**HISTORIC LANDMARK COMMISSION
OCTOBER 28, 2013
NATIONAL REGISTER HISTORIC DISTRICT
NRD-2013-0072
Old West Austin
1415 Ethridge Avenue**

Demolish a non-contributing house and construct a new 3,980 sq. ft. house.

ROOF PLAN
SCALE 1/8" = 1'-0"

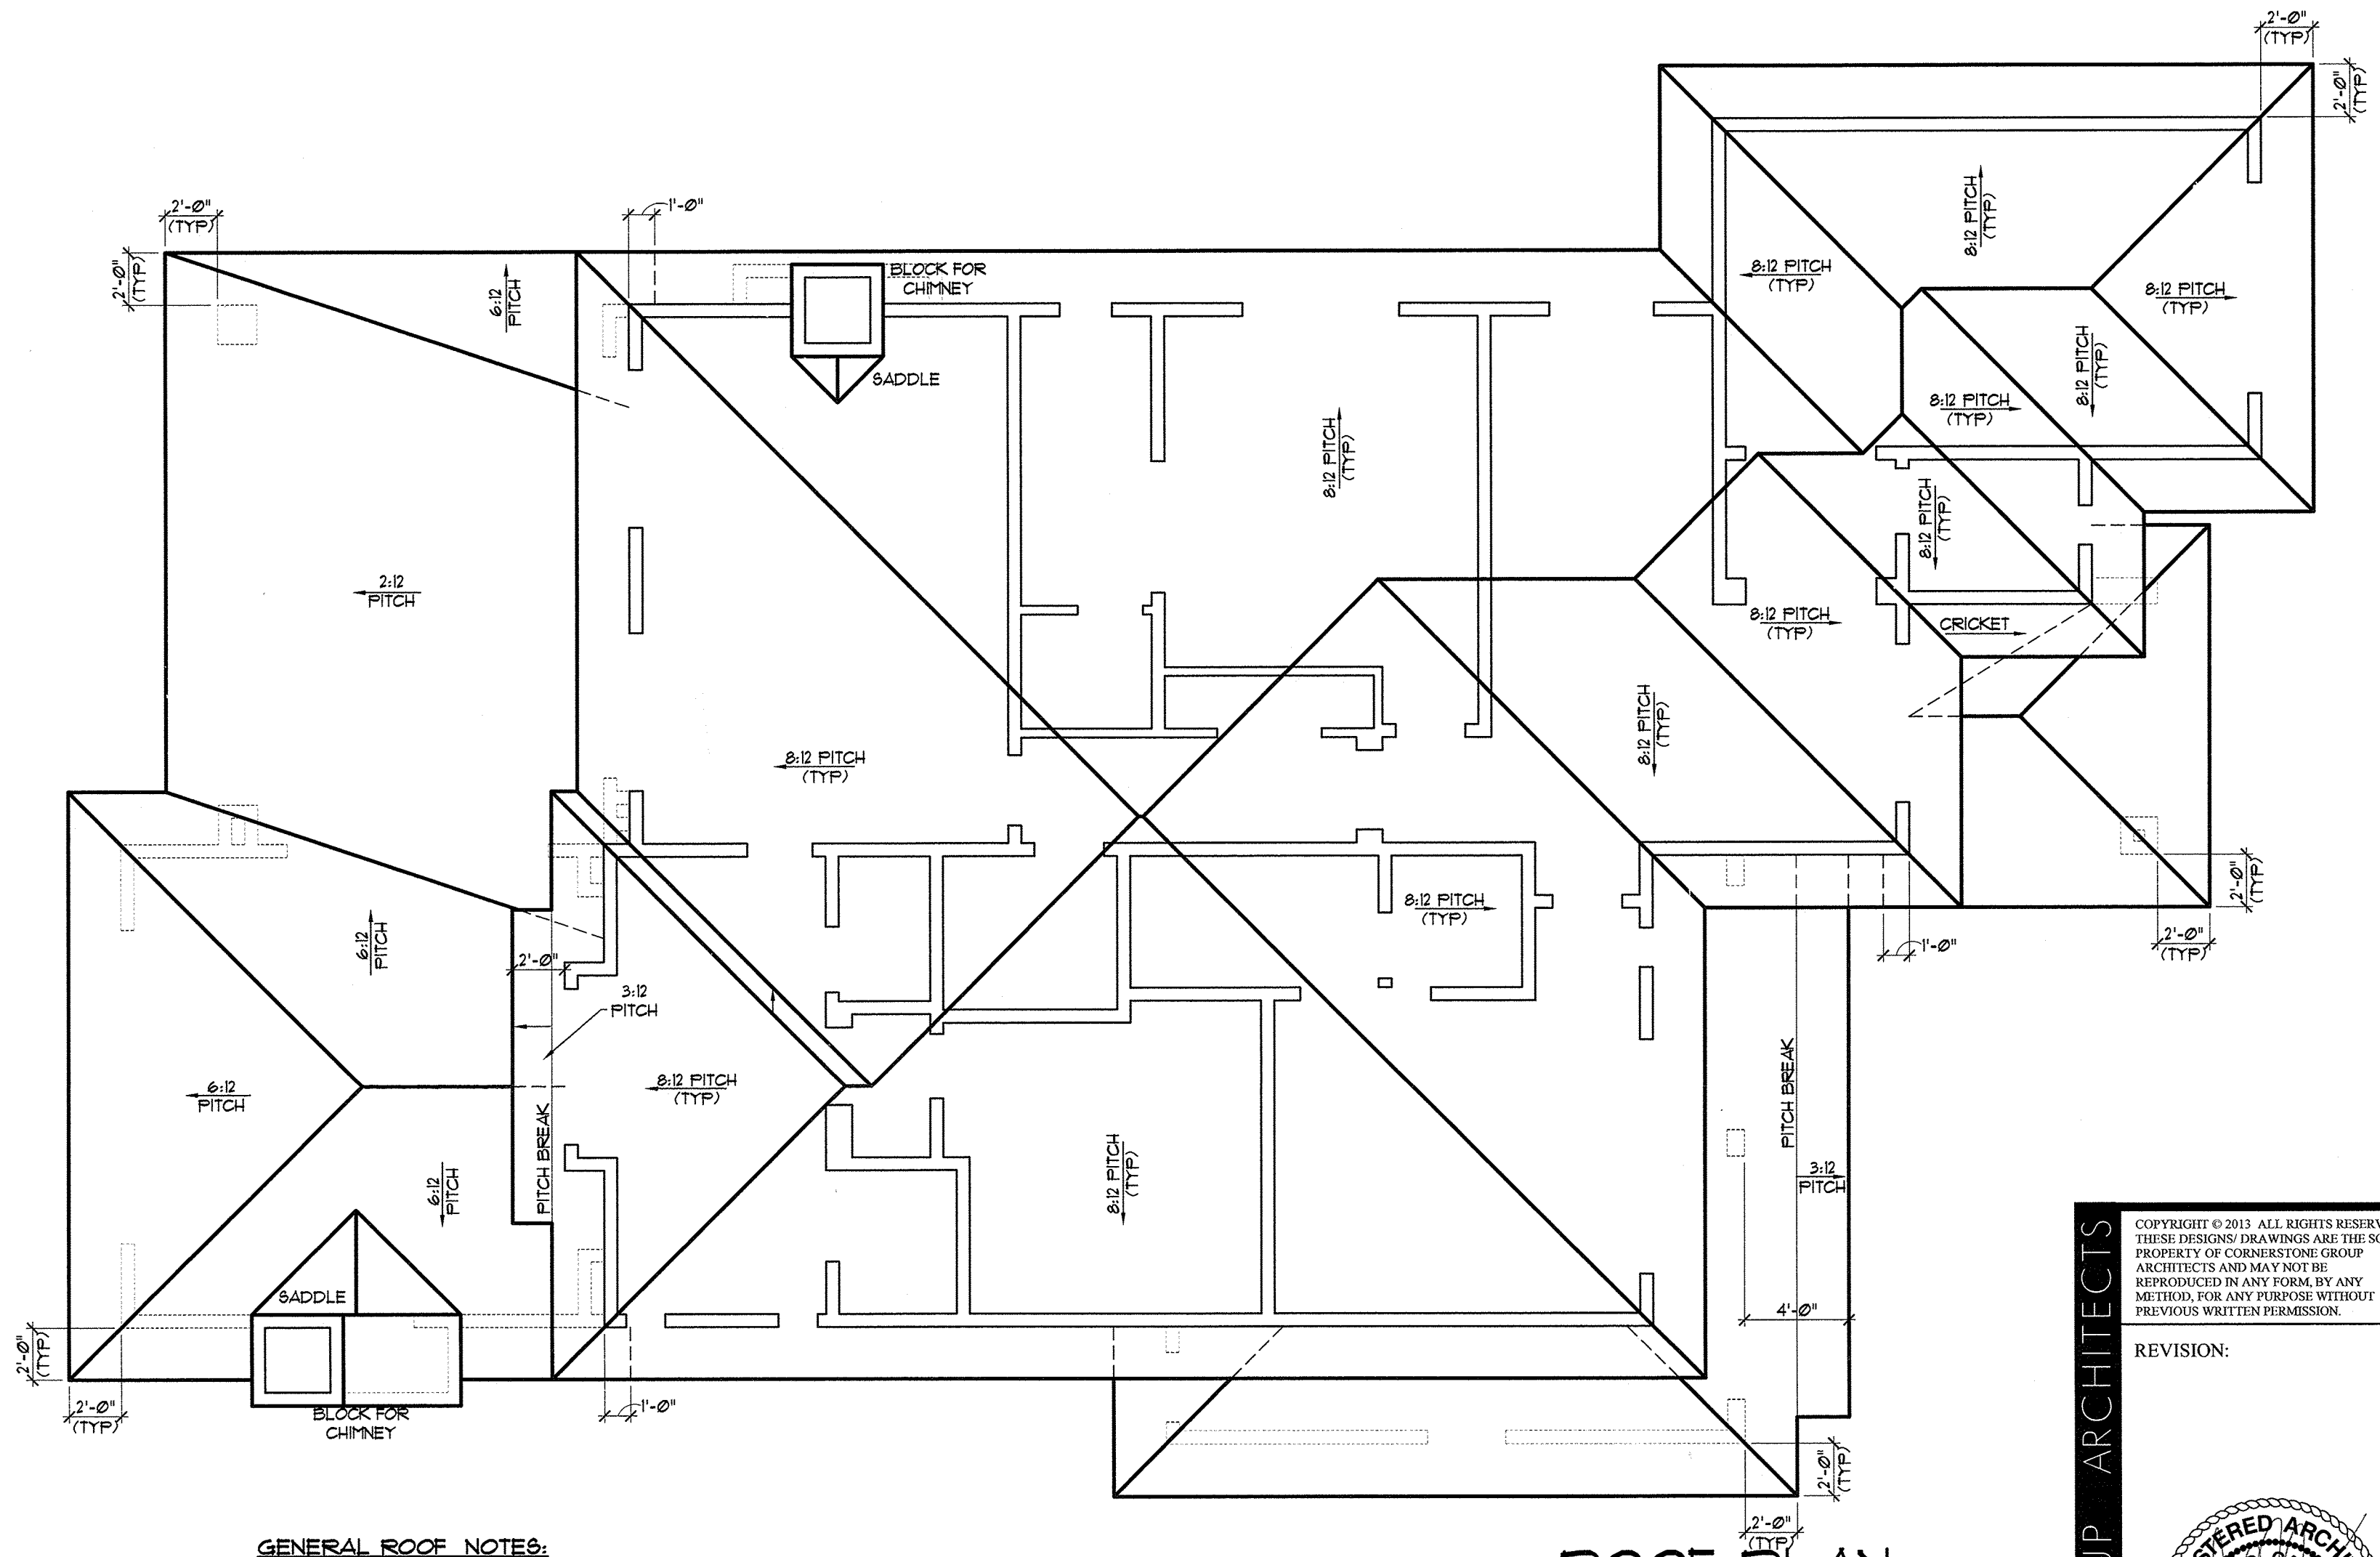
Most of the properties on this block of the District have large, two-story houses, some with front facing, attached garages. Although the design is contemporary, the scale, massing, and materials are generally compatible with other properties in the area of the District. However, the multiple hip roofs do not reflect the architectural form of either contributing or non-contributing properties on the block, most of which have more simple side gable or hip roofs.

Release the permit per the proposed design with the recommendation that the applicant simplify the roof form.
